Case File / Name: ASR-0086-2020 Meridian at North Hills City of Raleigh
Development Services Department
One Exchange Plaza
Raleigh, NC 27602
(919) 996-2492
currentplanning@raleighnc.gov
www.raleighnc.gov

Administrative Site Review

Meridian at North Hills

A300

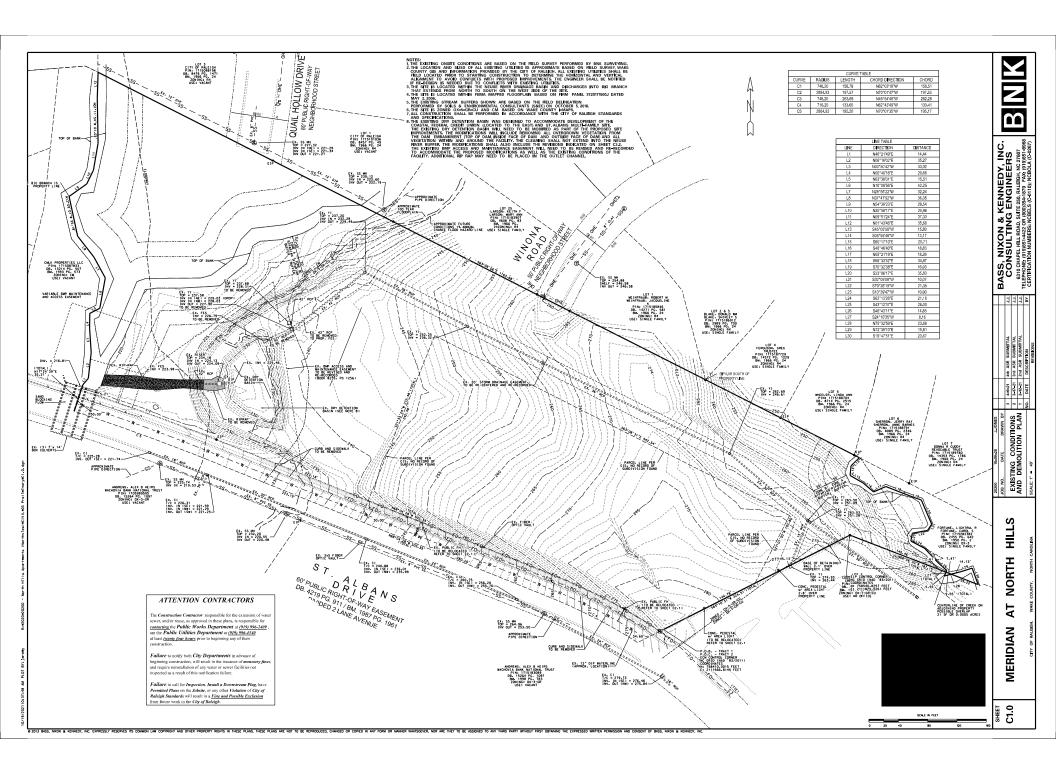
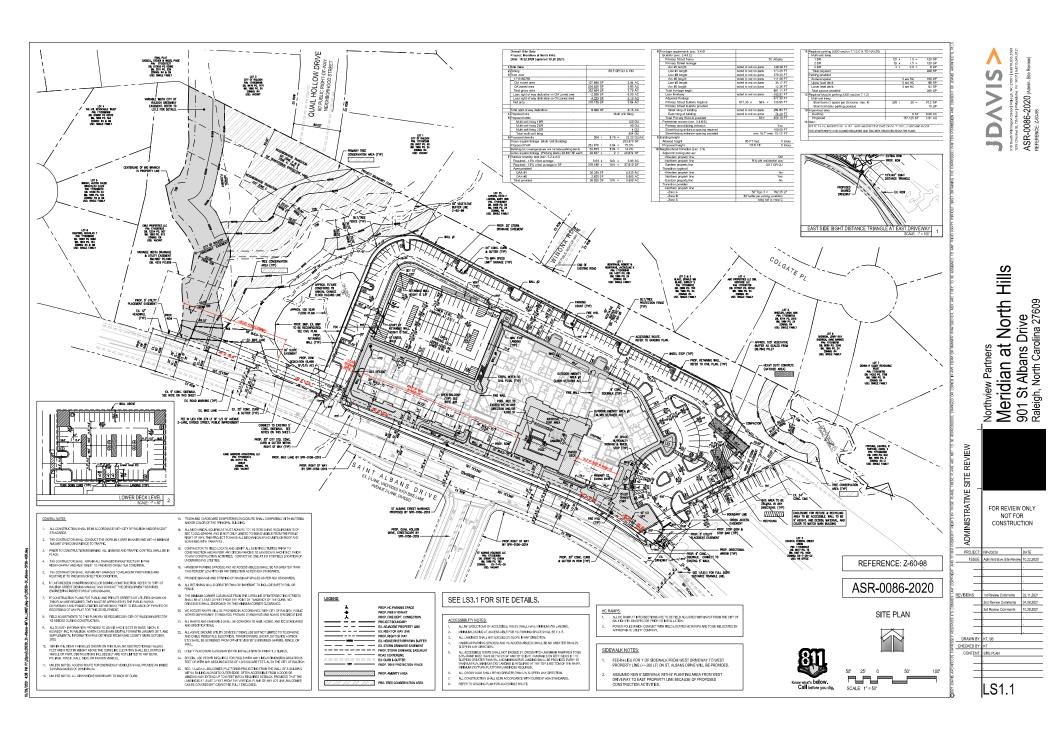
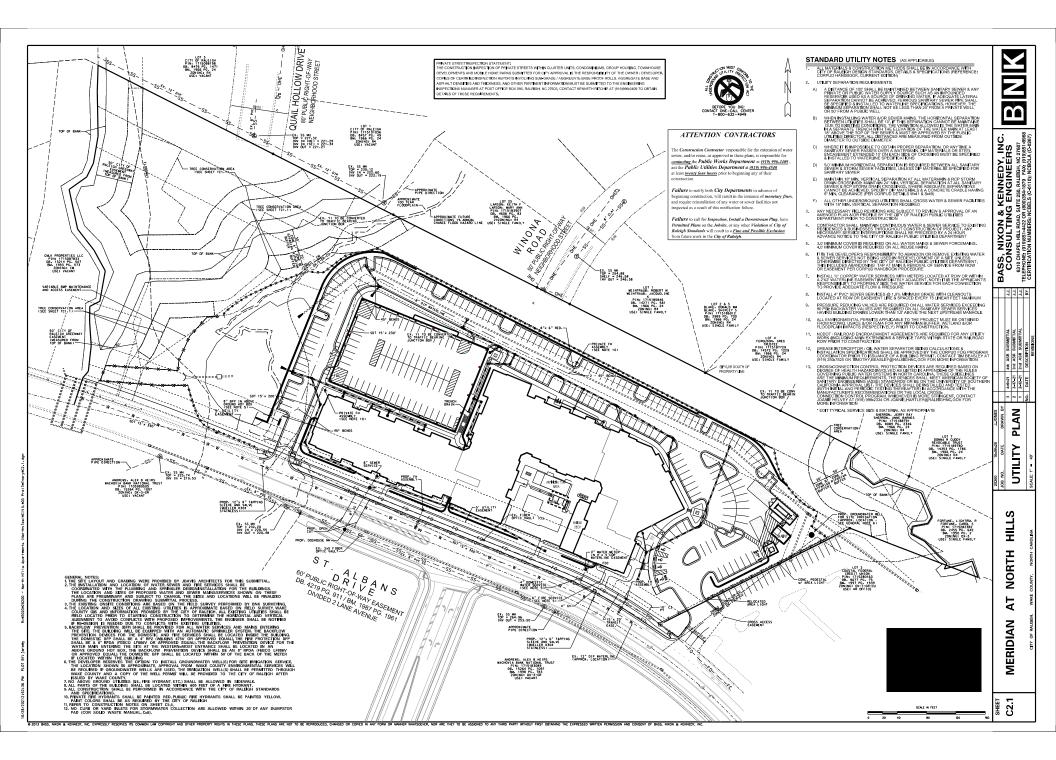
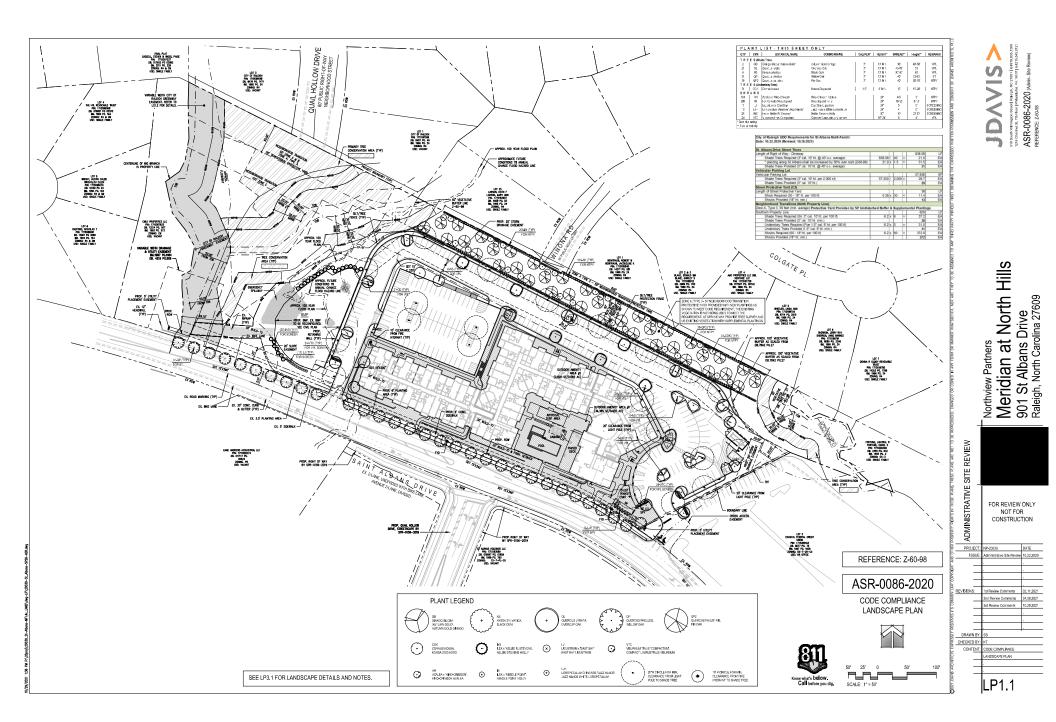
- The TW/BW grades for stand-alone & or foundation wall heights along the Sections B & C or walls #4,5 & 6 shown on the South Elevation, are properly labeled on sheet A300, demonstrate comply with TC-19-19 and UDO Sec.7.2.8.
- 6. The Green Frontage setback data information, per UDO Sec.3.4.6.C.C1, is listed and provided on the site information table under #8, on sheet LS1.1.
